RE: **ERAU Fitness Complex - Prebid RFI Responses**  
Project Number: 20-001  
PREBID RFIs #093-152

The following narrative lists the responses to the Prebid RFIs submitted during the bid phase of the ERAU Fitness Complex project. Following each question is the Design Team response.

## PRODUCT DETAIL

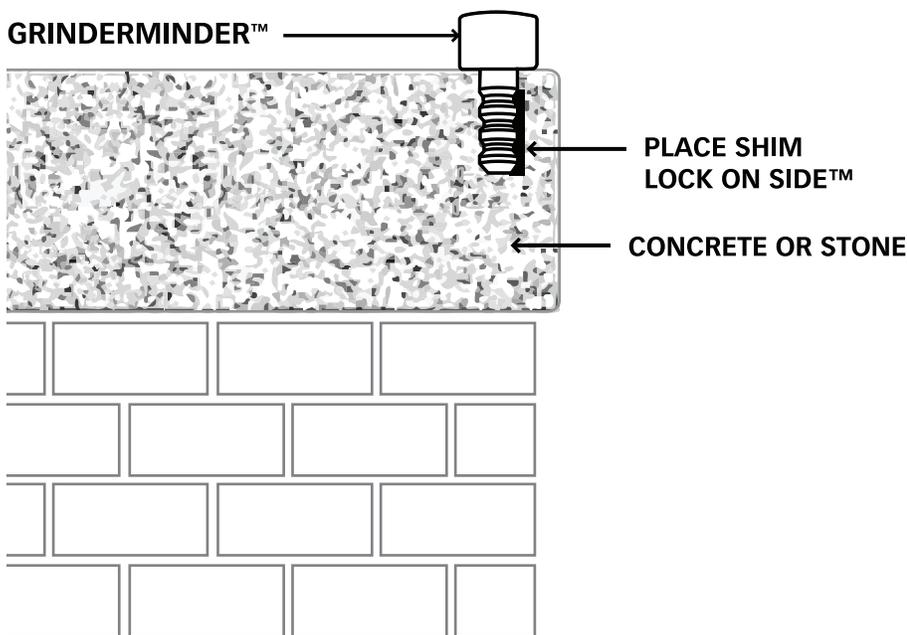
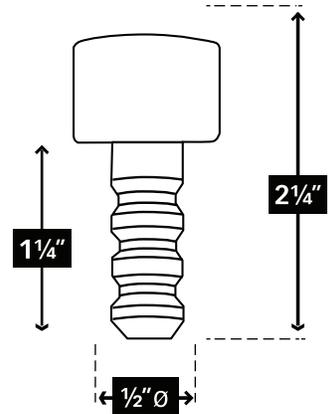
**Response: The climbing wall finish requirement shall have a flame spread and smoke developed index classification B.**
- 115) Please specify B.O.D. for the skateboard deterrent stud at the entry pedestals.

**Response: Basis of design is solid stainless-steel Cylinder GrinderMinder 1"x1" with brushed finish. Manufacturer: Grind To A Halt, Inc. [www.grindtoahalt.com](http://www.grindtoahalt.com). See attached.**

6  
 SHEET NO.  
 Drawn By: MRB  
 Date: 03/20/2020  
 SCALE: 1"=20'  
 JOB#: 20-17

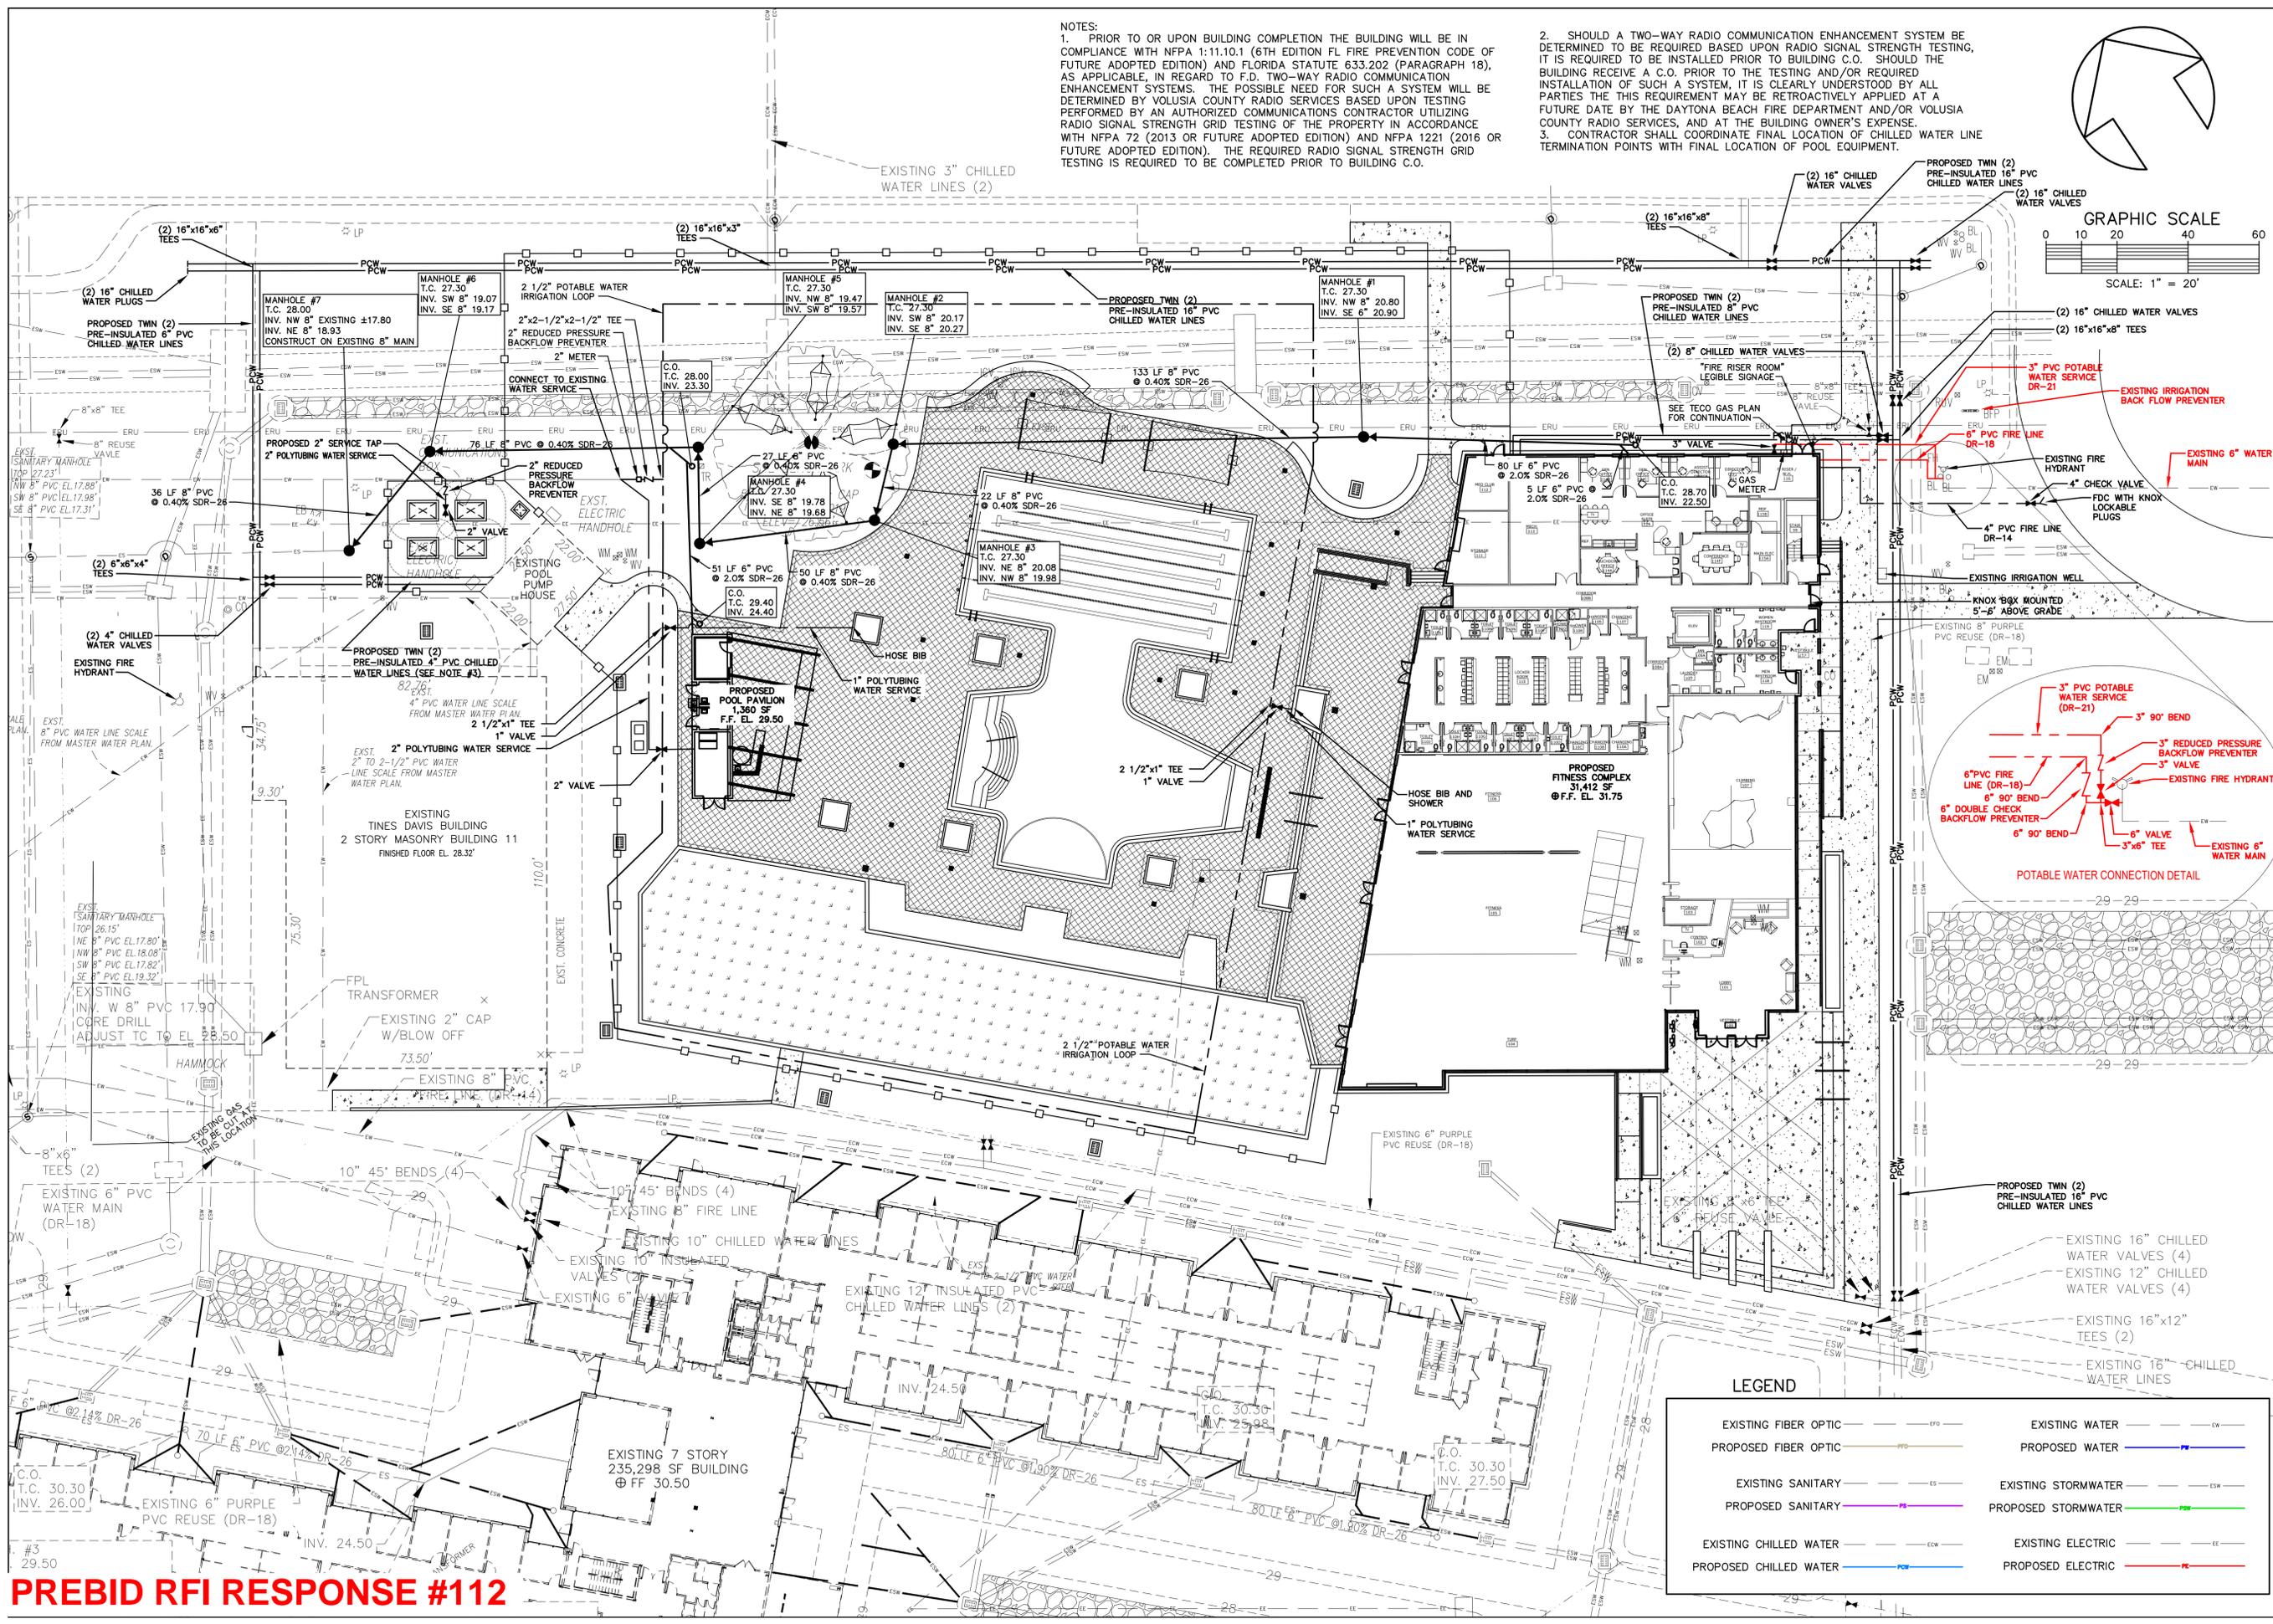
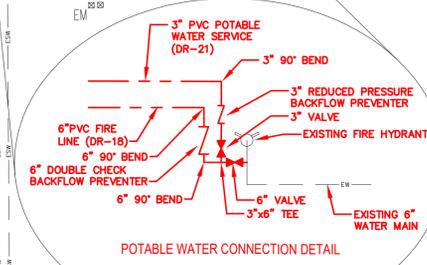
- 112) The backflow that connects to the site fire lines that is called to be existing on Civil Sheet 6 and FP0.010 appears to be a backflow for the existing irrigation system. Please advise if a new BFP is required for the site fire lines.

**Response: See revised Sheet 6 (dated 09/10/20) attached. Revisions are highlighted in red.**
- 113) Will the Owner's Testing Agency cover the spec 131200 3.6 required structure testing for the climbing wall?

NO.	DATE	DESCRIPTION	BY
4	09-10-20	REVISED POTABLE WATER CONNECTION	MRB
3	08-13-20	BID SET	MRB
2	09-06-20	REVISED	MRB
1	07-24-20	REVISED	MRB
